July 23, 1996
PY-CEI/NRR-2079L

Perry Nuclear Power Plant
Docket No. 50-440
10CFR50.54(a)(3) Organization Change for the Perry Nuclear Assurance
Department and the Perry Training Section

10CFR50.54(a)(3) Organization Change for the Perry Nuclear Assurance Department
and the Perry Training Section - Supplemental Information

Figure 13.1-5

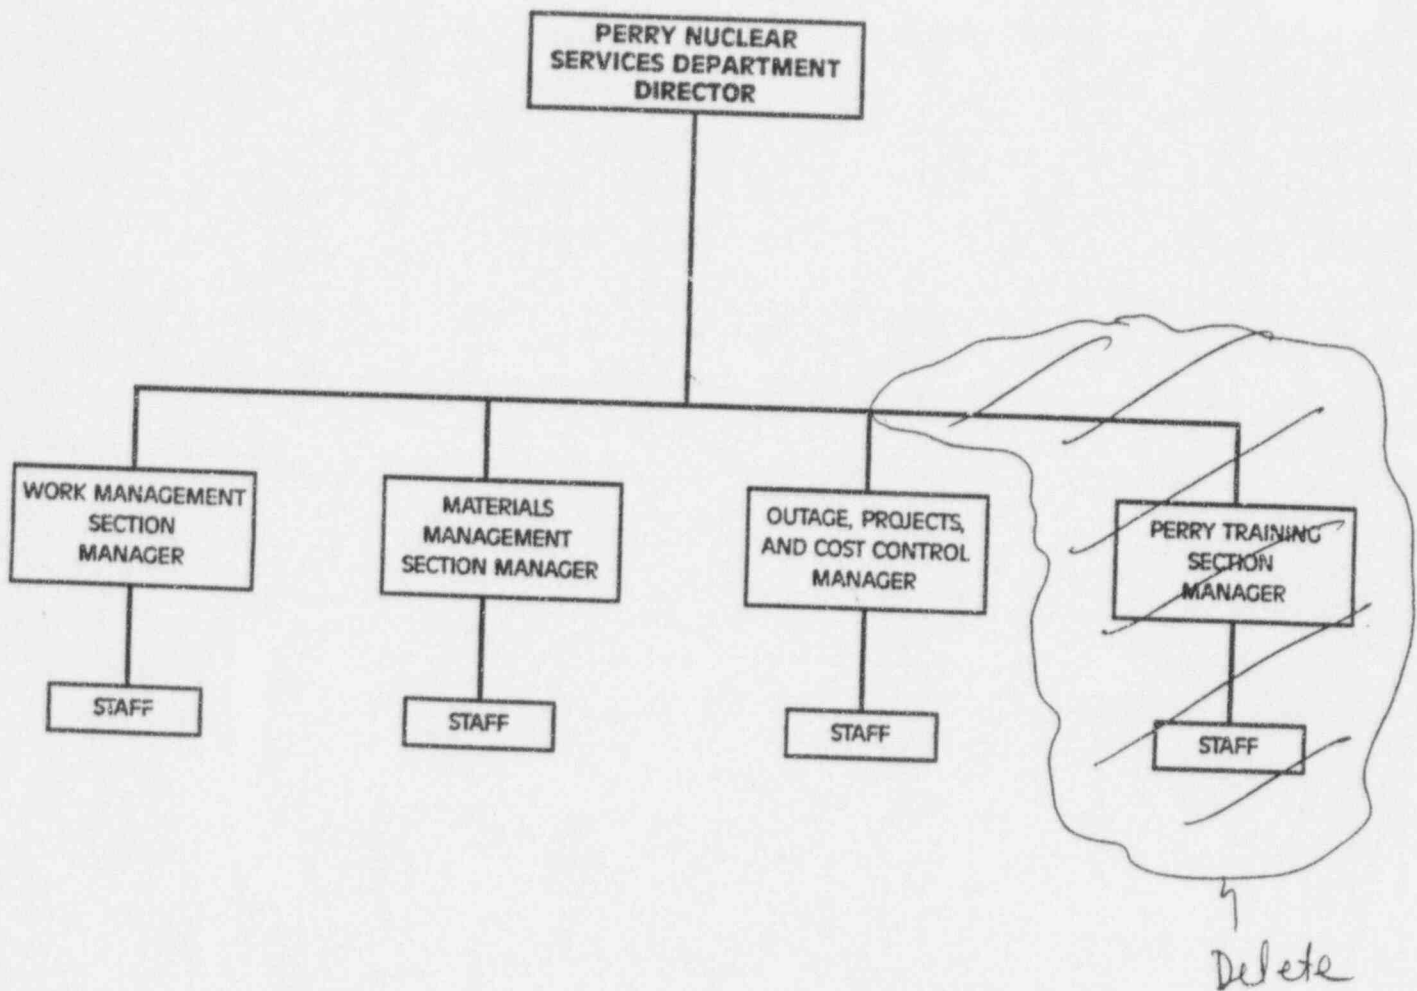
The Perry Nuclear Services Department consists of ^{three} ~~four~~ sections: Work Management, Outage, Projects, and Cost Control, Materials Management ^{and} ~~and Perry Training~~ Sections. The responsibilities of each element are discussed in Section 13.1.2.2.3.

Figure 17.2-2

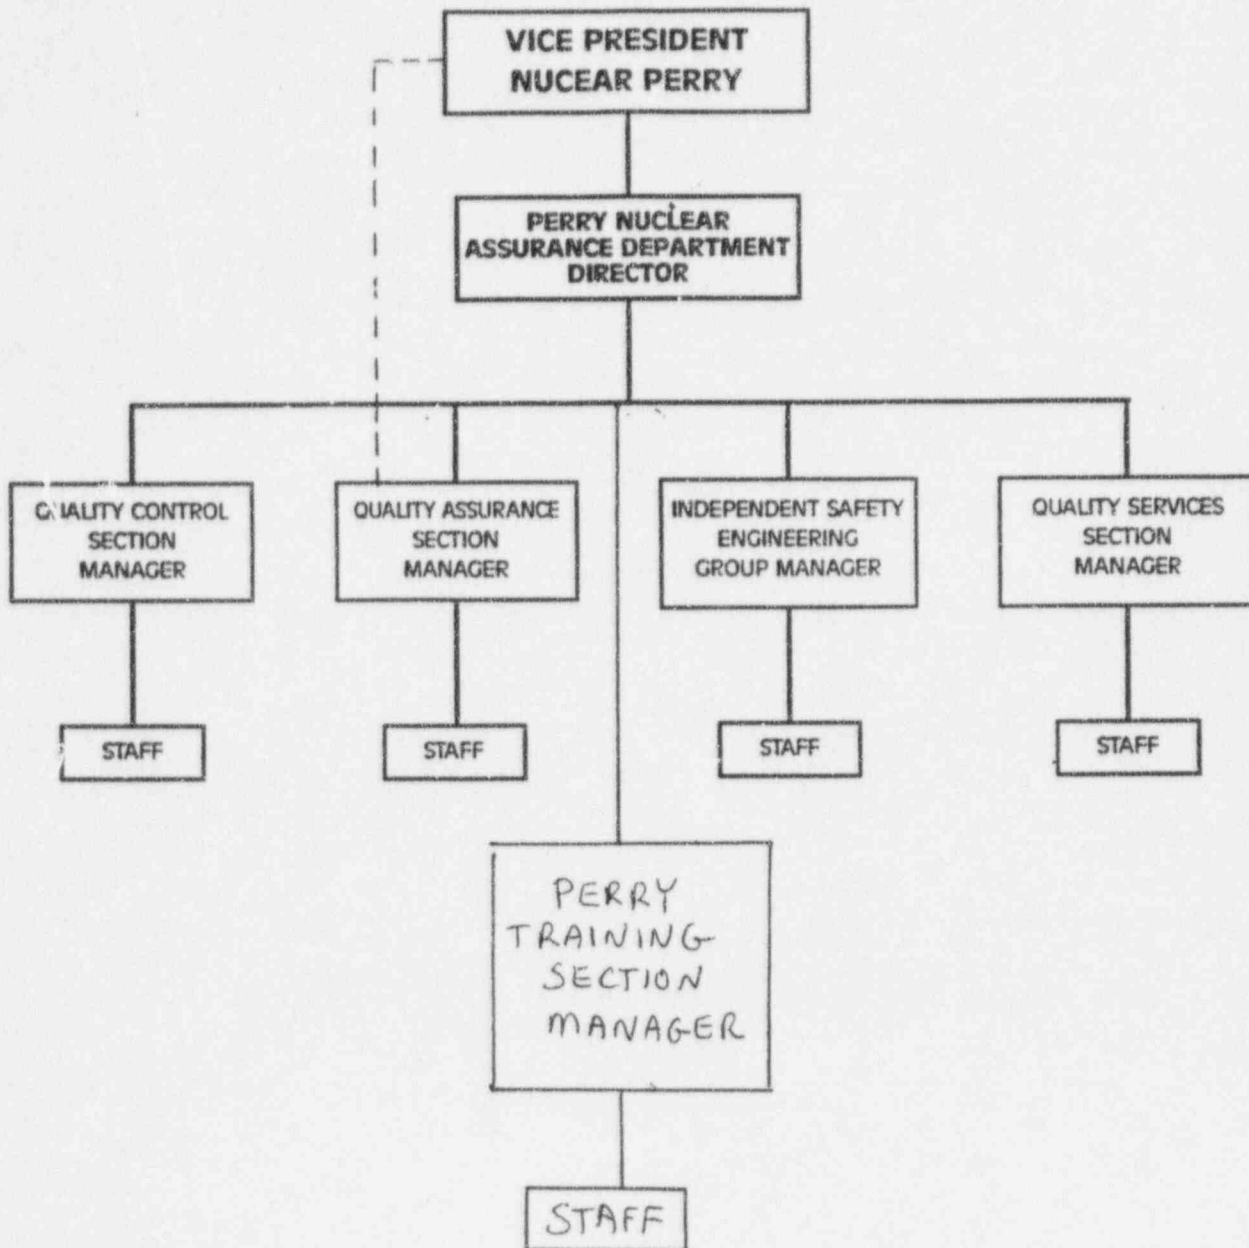
17.2.18.3.1 ~~Director, Perry Nuclear Assurance Department~~

The ~~Director, PNAD~~, is responsible for providing for a system of planned and ~~systematic~~ audits of organizations performing safety-related
